From: Andrew Parker
To: Yu, Olivia, EMNRD, Mann, Ryan
Cc: Billings, Bradford, EMNRD, naranjo@pride-energy.com, Randall Hicks
Subject: [EXT] RE: Pride Energy NM 87 State 001 (Tank Battery) 1RP-4625
Date: Tuesday, October 23, 2018 9:47:28 AM
Attachments: Tank Battery - Response to NMOCD oct 2018 email.pdf

RE: **Response to NMOCD's October 4th and 7th, 2018 email**

Operator: Pride Energy Company
NM 87 State #001 (**Tank Battery**)
API#: 30-025-23655
Section 33-14S-34E: Unit K
Lea County, New Mexico
Site Characterization Report and Remediation Plan 1RP-4624

Typical Reserve Pit Layout in 1970s.
 Aerial Photo (Dec. 1971)
 Pride Energy Company
 NM 87 State #001 (Tank Battery)

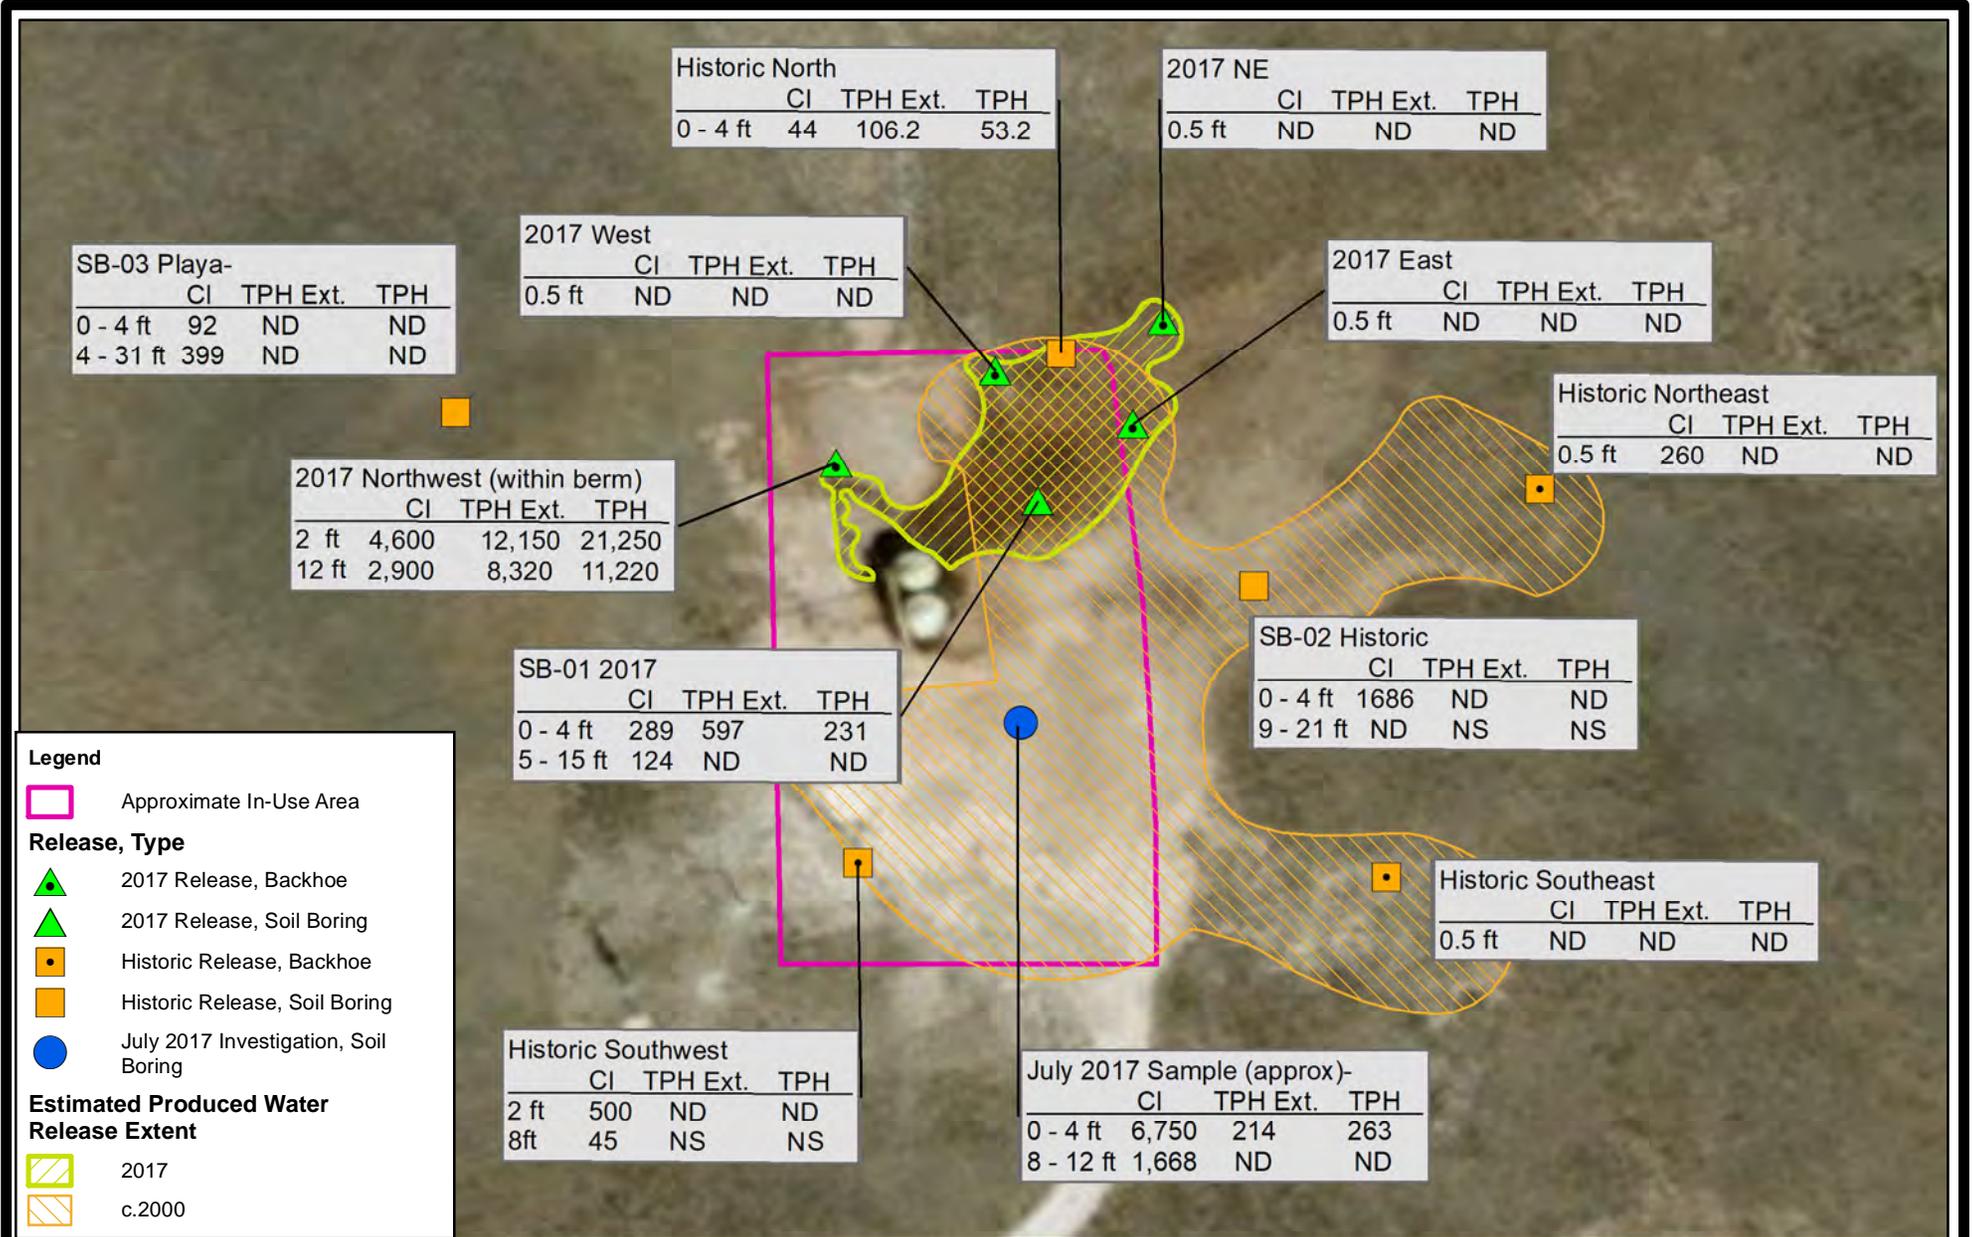
Relevant comments stated for 1RP-4624 are applicable to 1RP-4625. NMOCD will not grant deferral for remediation until release characterization/delineation is completed for 1RP-4625. Delineation for TPH extended are still required for the area represented by NW berm. If the tank battery is situated on top of a drilling pit, please provide documentation for verification.

For sampling locations within areas “in-use” only the 2017 Northwest (within berm) location shows TPH above Table 1 limits. As shown in Exhibit 2, the area is most likely within a former reserve pit. In the 1970s, when wells were originally drilled, a reserve pit was commonly constructed north of the wellhead and unlined. The left panel on Exhibit 2 is an example of a reserve pit captured in a December 1971 aerial photograph - 1.7 miles northwest of the tank battery location.

The 6th sample location is the 2017 Northwest (within berm), which exceeds Table 1 limits. As discussed above, the berm area is most likely within a former reserve pit dating back to the 1970’s. Per 19.15.29.12.C.(2), we ask NMOCD to defer the restoration around the active tank battery and ask for a variance per 19.15.29.14 from fully delineating the berm area. As presented in our August 2018 report, Pride Energy will place a geosynthetic liner around the active tank battery, within the berm area, to:

Exhibit 1
 October 2018

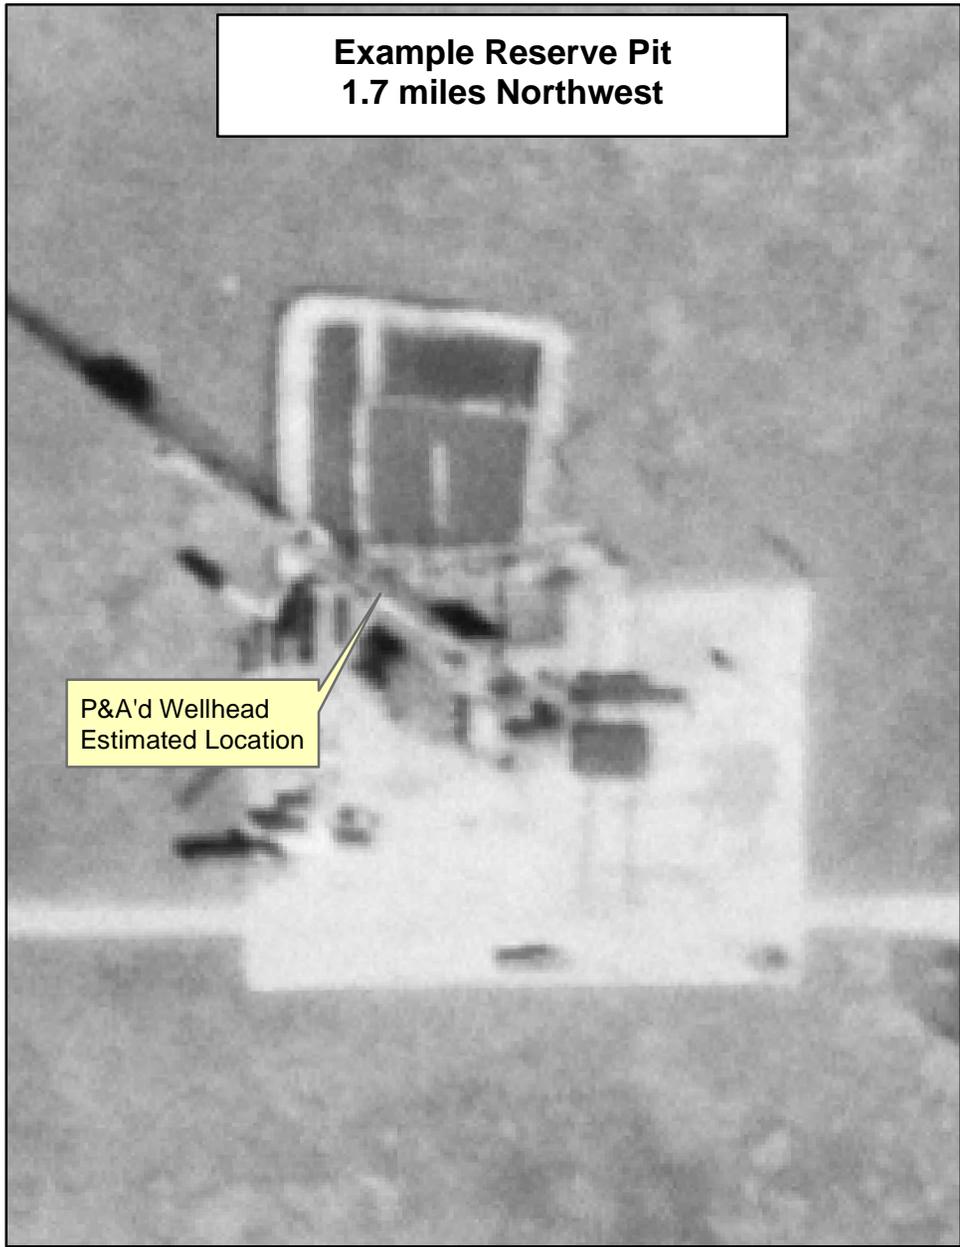
The release area around the tank battery, represented by NW berm data, and well pad, represented by TT-1 July 2017 data, will need additional vertical delineation.

As shown on Exhibit 1, attached, the pink outline defines the "in-use" area based upon historic aerial photos, a current aerial photo, and site reconnaissance of the active tank battery. Pride Energy acquired the former salt water disposal location in February 2007 and has no survey plats in their files. The former well was first spudded in 1970. No site specific survey exists in NMOCD's online files. Mr. Mann with the State Land Office has not survey plats showing lease extents.

Included on Exhibit 1 are chloride and TPH concentrations in mg/kg. Sample depths showing a range were averaged from discrete samples. Discrete sample depths are noted

was omitted from further vertical delineation. The two exceptions were SB-03 Playa and SB-02 Historic. SB-03 Playa was vertically delineated at the request of the State Land Office. SB-03 Playa is below Table 1 limits including chloride <600 mg/kg in the upper 4-feet. Vertical delineation showed that SB-02 Historic requires reclamation for areas “no longer in-use” per 19.15.29.13.D and concurrence with the State Land Office.
